MODIFICATION #9  
STREET 'C' MODIFIED SECTION

Request for a  
Modification to a Road Standard  
and/or to Project Conditions

Project Number: TM 5571/5572 Date of Request: January 31, 2014

# ATTACHMENT 1 WITH MODIFICATION #9 STREET 'C'

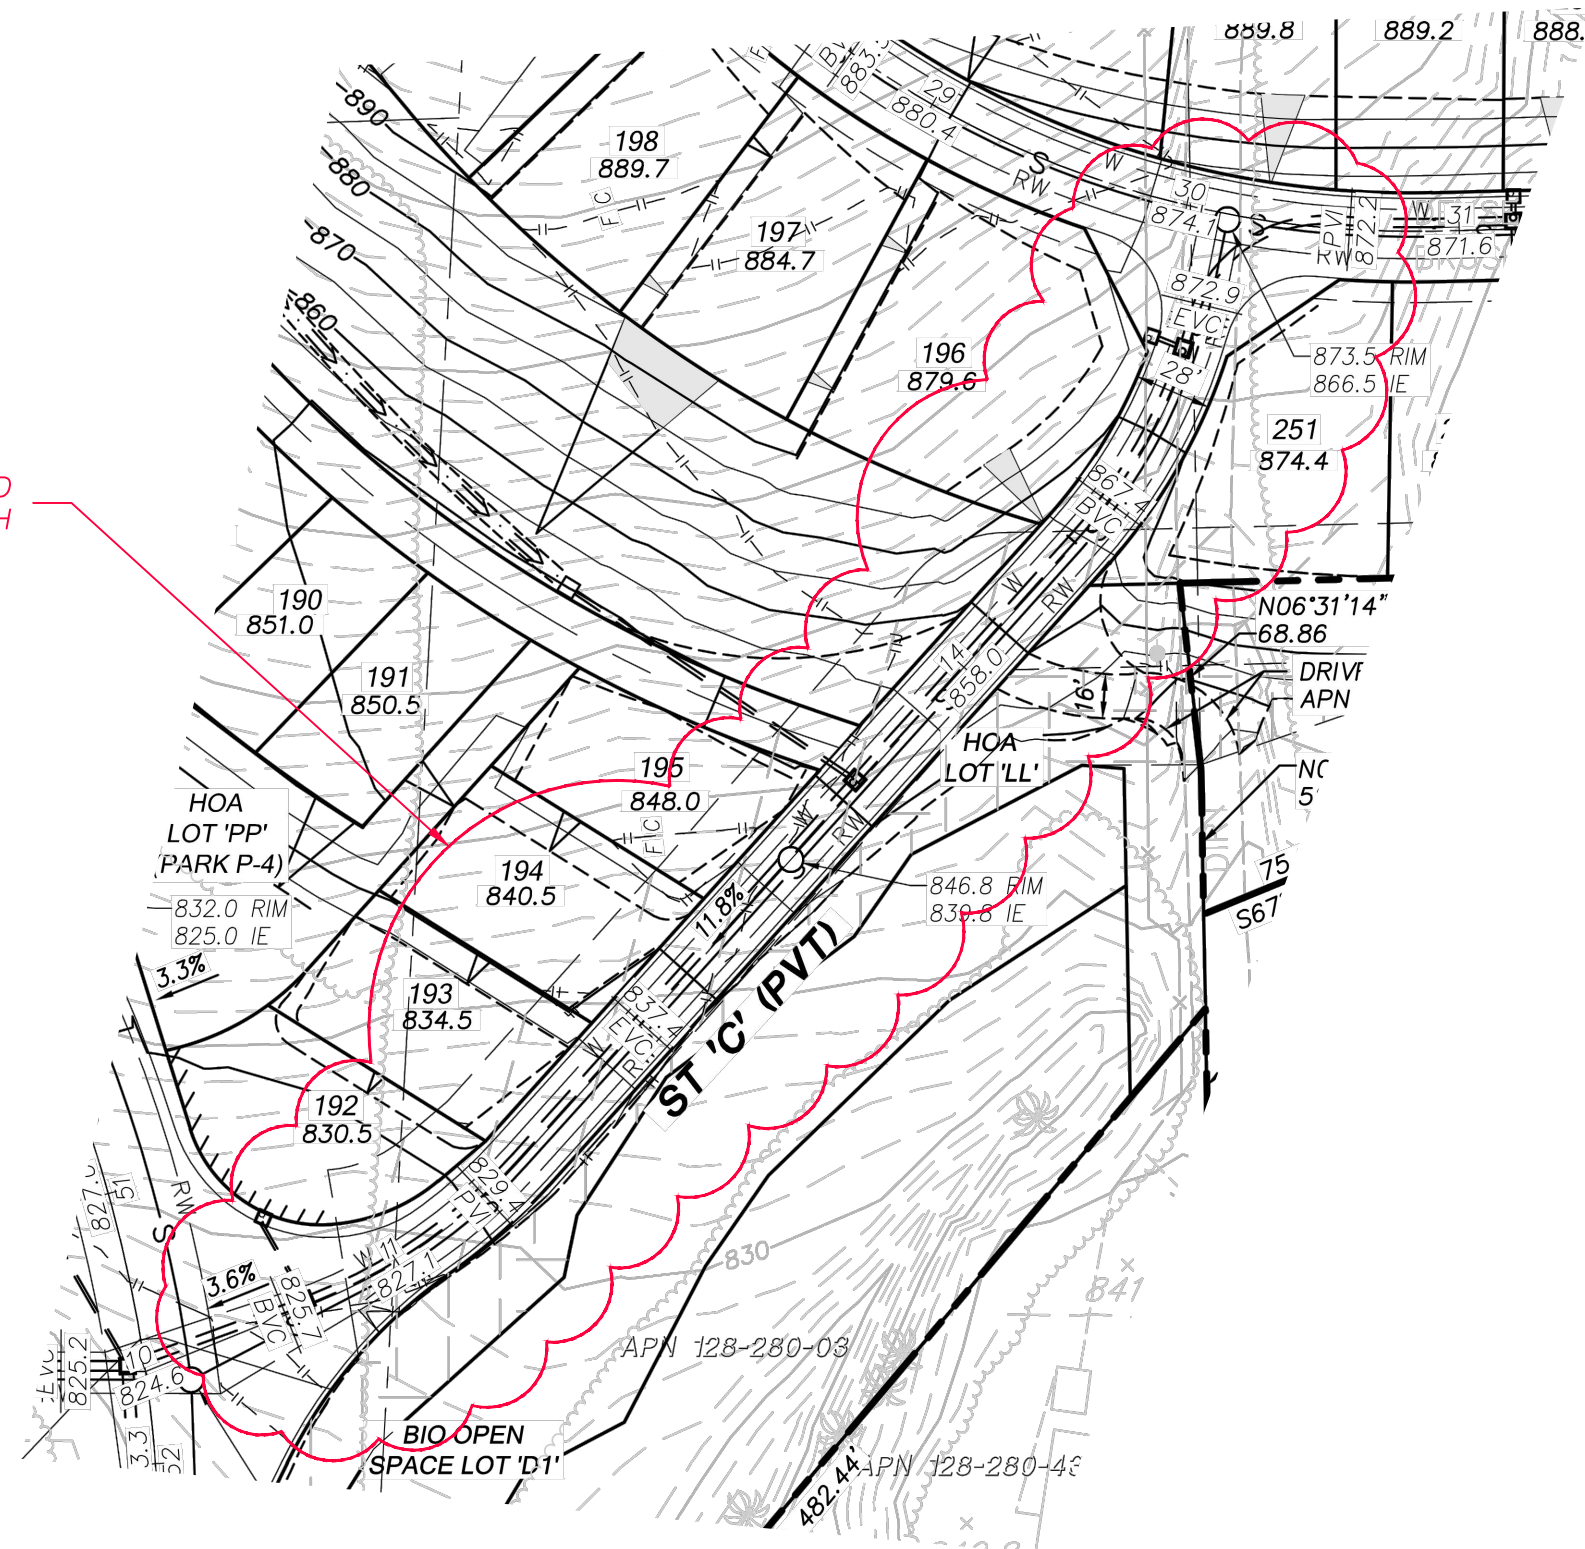
The standard road section for a Private Road is 24' paved width on 28' ROW with  
a minimum design speed of 30 mph. The requested modification to the road standard is  
to reduce the designed speed to 20 mph.

The Project goals and policies are specifically written to create a mixed-use pedestrian  
oriented community. The reduced design speed is essential in achieving pedestrian safety  
and walkability within the community. Further, through the reduced design speed and the  
proposed alignment, the road is able to follow the natural contours which will reduce  
the grading required for the project.

Describe the hardship(s) to the property owner(s) and/or neighbor(s) if the request is not approved (see note 3. on reverse): Increasing the design speed will require a new vertical curve design in a  
constrained distance (500') with manufactured slopes and wetlands on either side of road.

REDUCE THE DESIGN SPEED  
FROM 30 MPH TO 20 MPH
